**Department of Energy**

February 24, 1998

**DOE's Response to Comments  
Made by EEG to Docket A-93-02, dated 12/31/97**

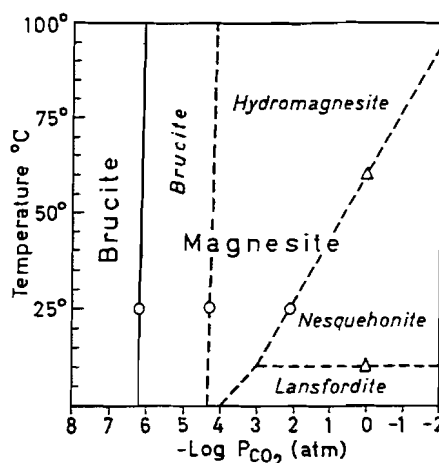
Perhaps the most important questionable assumption made in projecting the solubility values used in the CCA and the PAVT is the presence of hydromagnesite as the dominant stable mineral species resulting from the MgO backfill. DOE's experimental efforts with MgO predominantly produced nesquehonite, a magnesium carbonate mineral with the later appearance of an unidentified phase. Hydromagnesite was not formed in the experiments reported by the DOE (Van Bynum's 4/23/97 report); a hydromagnesite-like unnamed mineral is reported. The chemical structure of this mineral is in fact more like nesquehonite. The DOE and the EPA believe that "hydromagnesite will be the metastable hydrated magnesium carbonate phase and nesquehonite will be an intermediate phase." (EPA Technical Support Document III-B-17, p.2). There is no experimental data for the length of time that nesquehonite is expected to exist. The distinction between the projected hydromagnesite-dominated or nesquehonite-dominated chemical environment in the repository is important because the actinide solubilities in the presence of nesquehonite are 3 to 4 orders of magnitude higher than in the presence of hydromagnesite.

As CO<sub>2</sub> is generated, the partial pressure of CO<sub>2</sub> (pCO<sub>2</sub>) will begin to increase. On the phase diagram (Figure 1), the reaction path, therefore, begins at 25°C at the left, and moves isothermally to the right. Brucite is present in the system. The pCO<sub>2</sub> continues to increase until the hydromagnesite-brucite join is met, at approximately 10<sup>-4.2</sup> atm pCO<sub>2</sub> (Figure 1). That point on the phase diagram is the invariant point. Because the moles of emplaced MgO exceeds the maximum possible amount of CO<sub>2</sub> generated by a factor of nearly four, the phase diagram shows that nesquehonite will never be produced in the WIPP.

In conclusion, the DOE strongly believes that the appropriate actinide solubility calculation for the WIPP should be constrained by the hydromagnesite-brucite system.

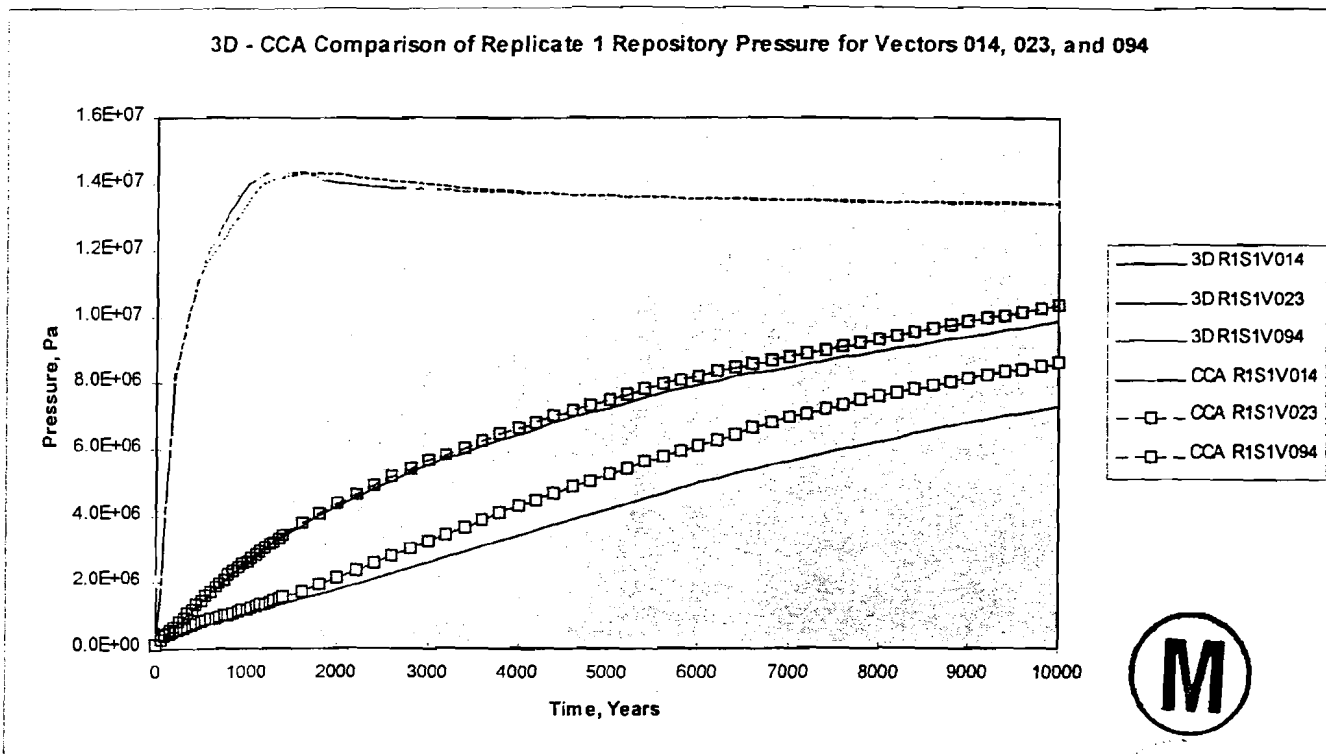
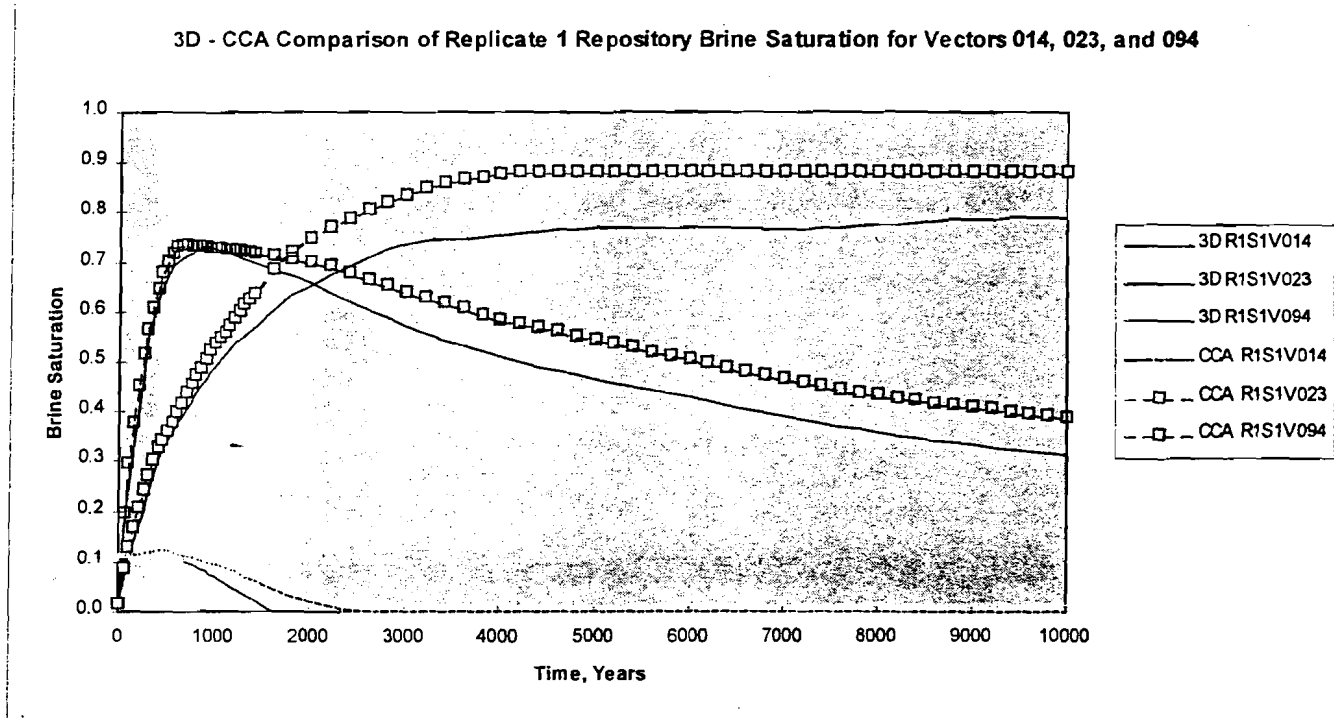
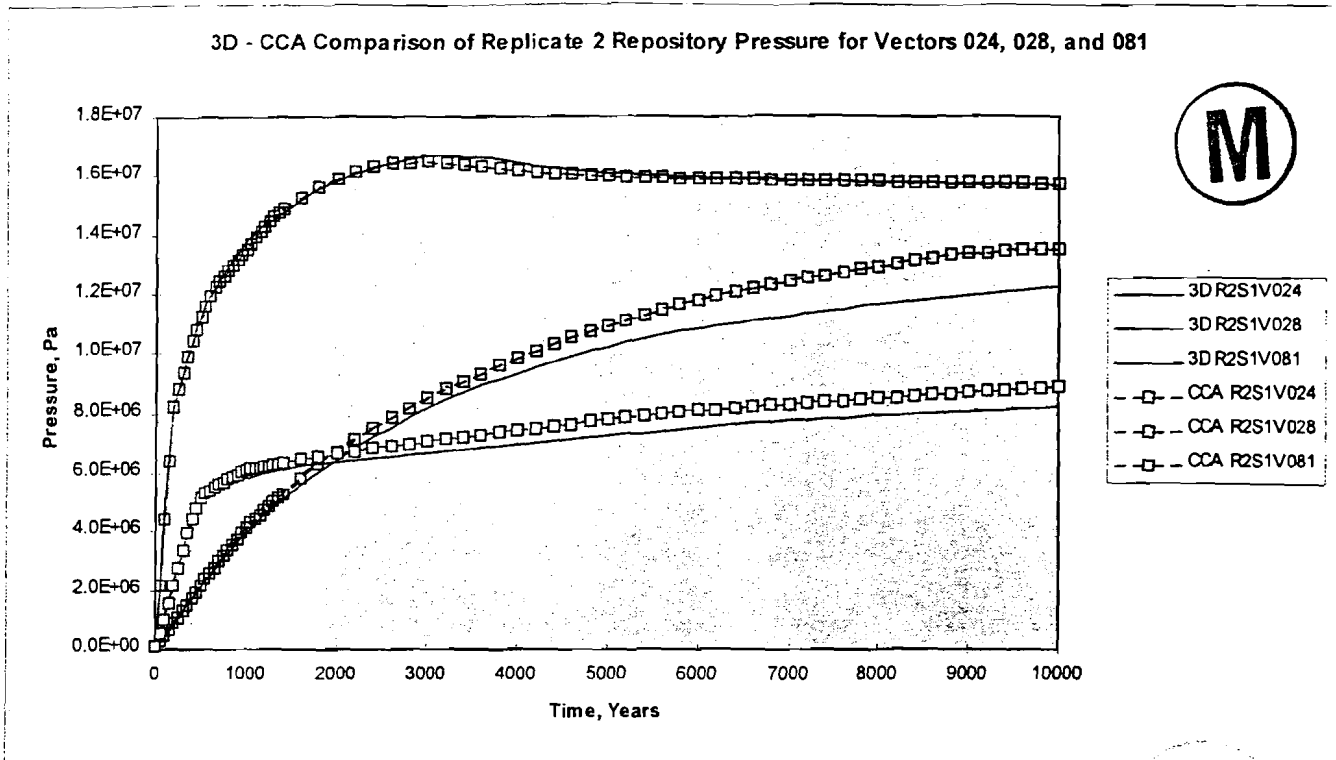
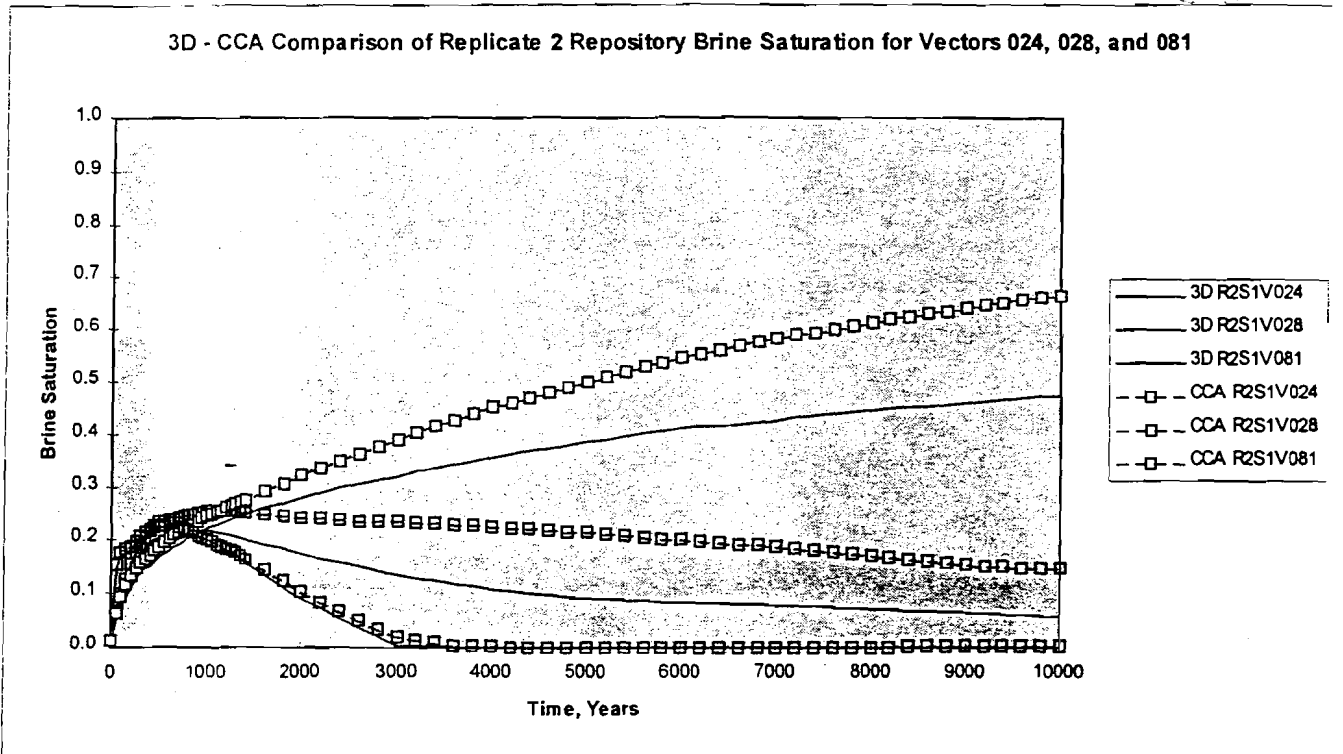
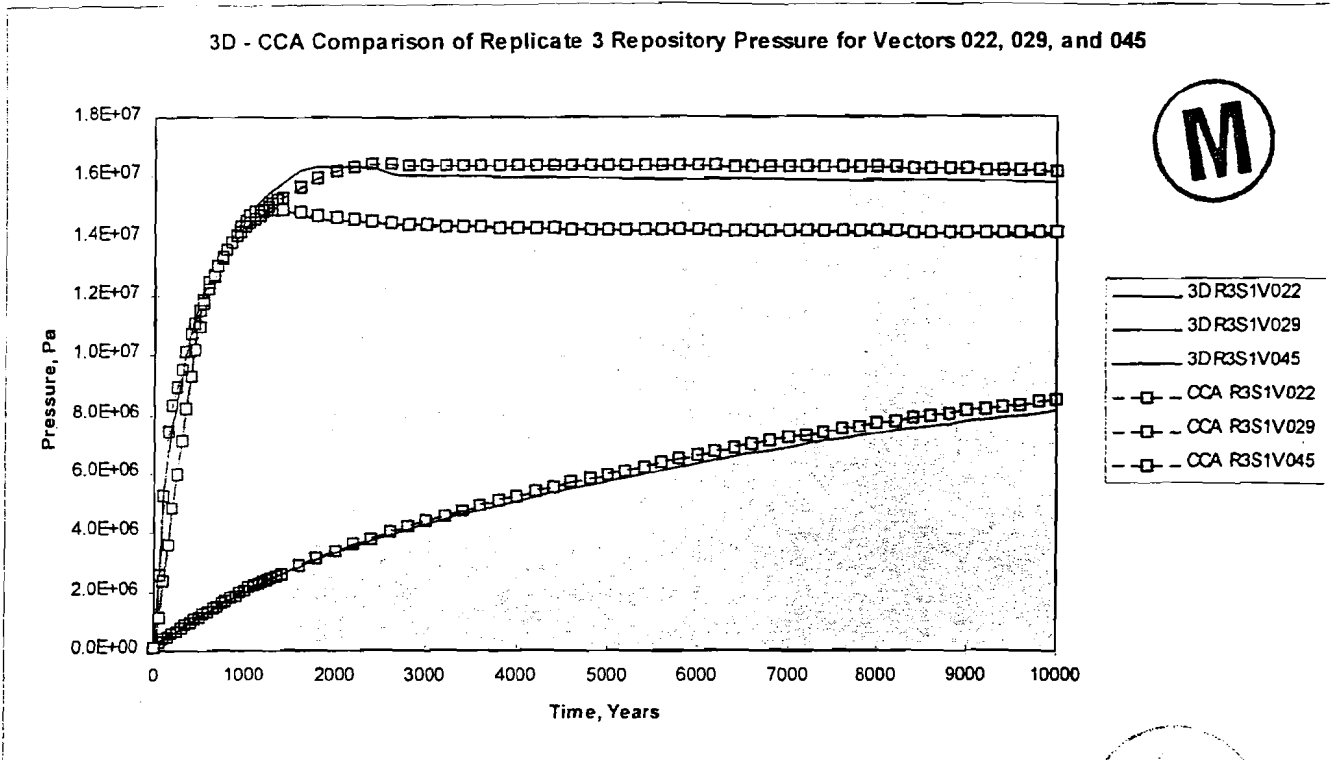
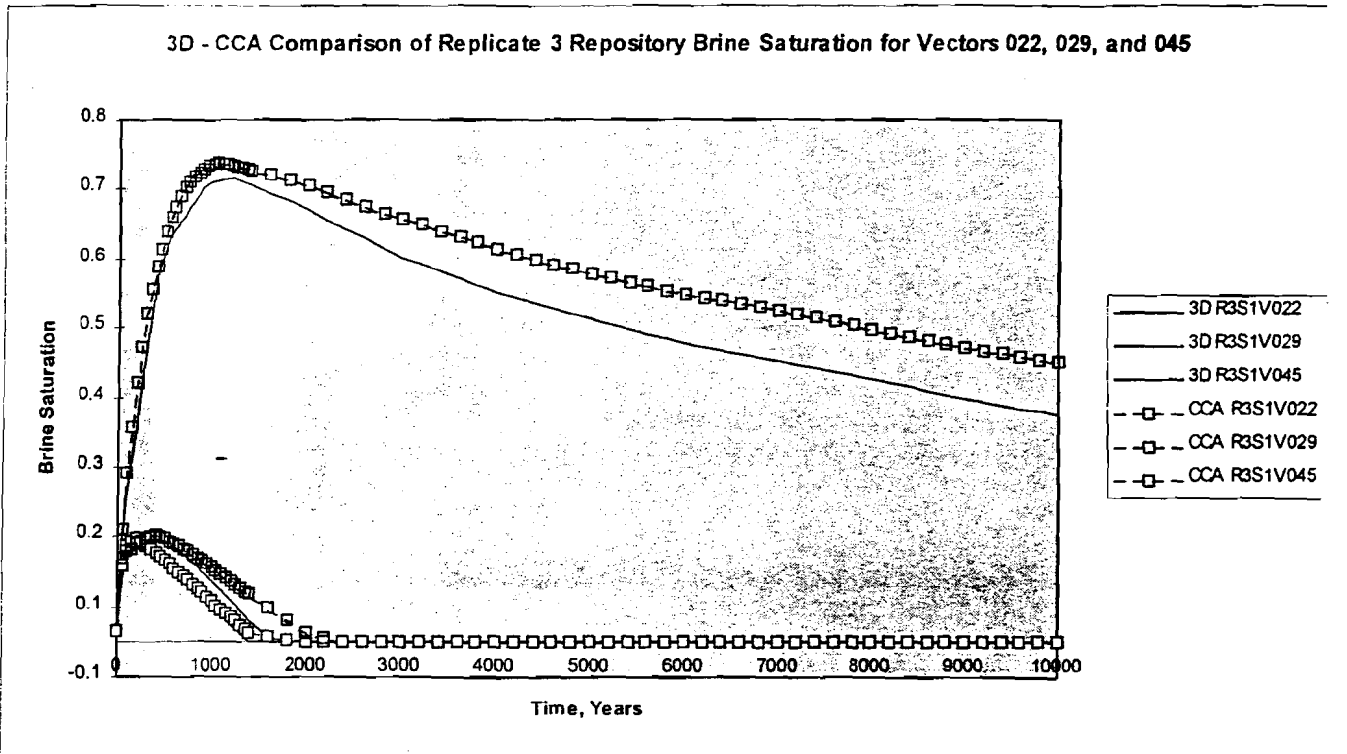
To resolve this issue, the EEG recommends that several 3D BRAGFLO simulations of the repository should be performed using the parameter values of vectors used in the CCA performance assessment. The 3D BRAGFLO simulations should be used to provide repository conditions for the normal suite of direct brine release calculations. The calculations should also be assessed in terms of impact on spillings calculations. Spallings simulations are probably not required to assess the impact. The following criteria may be used to select the CCA vectors for running the 3D simulations to bound the magnitude of the problem:

Additionally, more complex supplementary 3D calculations were performed in concert with EEG's recommendations made during discussions with EEG at a January 17, 1998 meeting (Vaughn, Bean, Schreiber and Dotson, 1998). These results collectively show that the 2D geometry used by BRAGFLO in the 1996 CCA performance assessment calculations is appropriate and does not result in an underestimate of direct release during human intrusion. In all cases investigated (10 simulations using 9 CCA realizations) the 2D simulations consistently predict either the same or larger repository pressure and brine saturation than their 3D counterparts. Both larger pressure and brine saturation in the repository at the time of intrusion would lead to larger releases. Thus, the 2D geometry results in a conservative estimate of the releases when compared to results from a 3D representation. These calculations are also reproduced in Attachment 1.

In figures 5 through 10 the repository pressure and the brine saturation resulting from an additional 8 simulations are compared between the 2-D CCA simulation and their 3-D counterparts. The characteristics leading to the selection of these additional realizations are outlined in an earlier section. Vertical fracturing is disabled in the 3-D simulations as justified in Attachment 1. Both the pressure and brine saturation in the 2-D version are either nearly the same or slightly larger than their 3-D counterparts. Since larger pressure and higher brine saturation result in larger releases during drilling, everything else being equal, the 2-D geometry used by BRAGFLO for the CCA calculations leads to a conservative (larger) estimate of release than the 3-D representation.
